Technical change to FieldPower® HQ Adapter

PCN-number: PCN-PB40-20190920-00-A

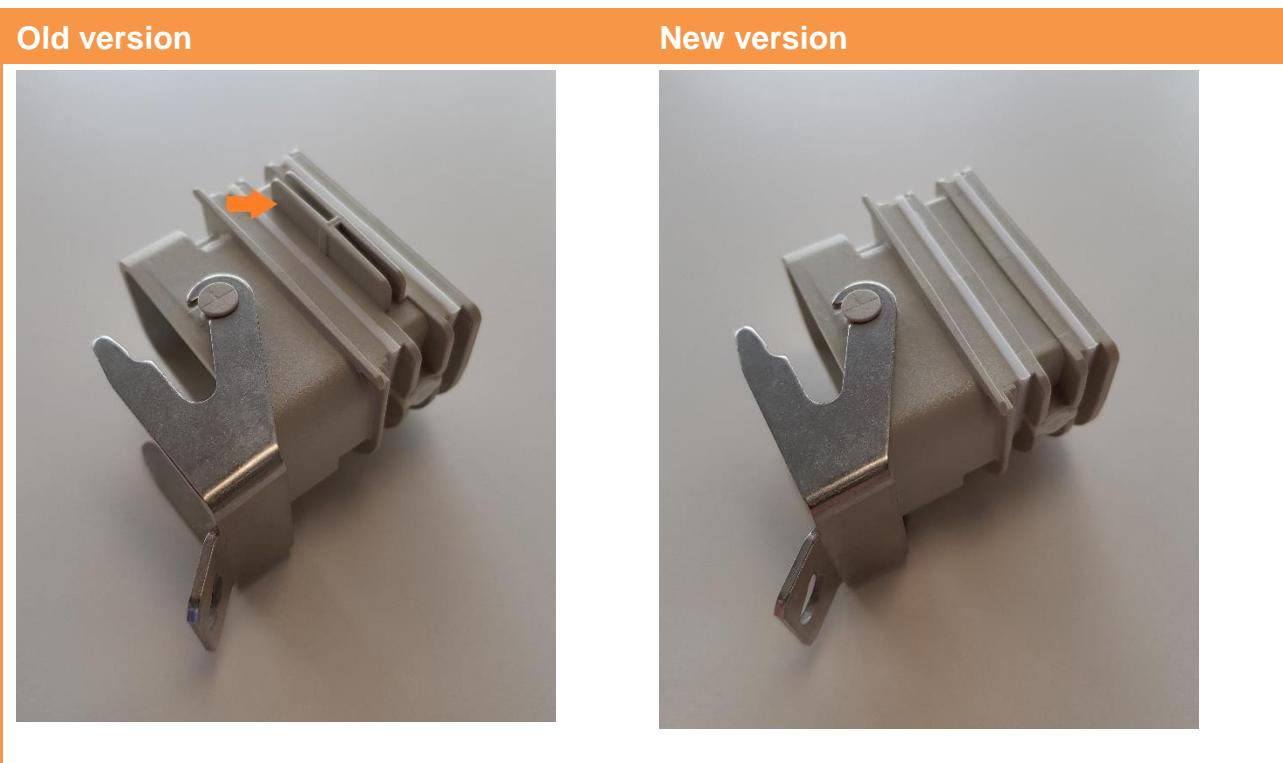
Plastic bar on FieldPower® HQ adapter.

The plastic bar has been removed from the HQ adapter. This has no effect on existing applications. This means that the adapter will be compatible with all FieldPower® lids in the future.
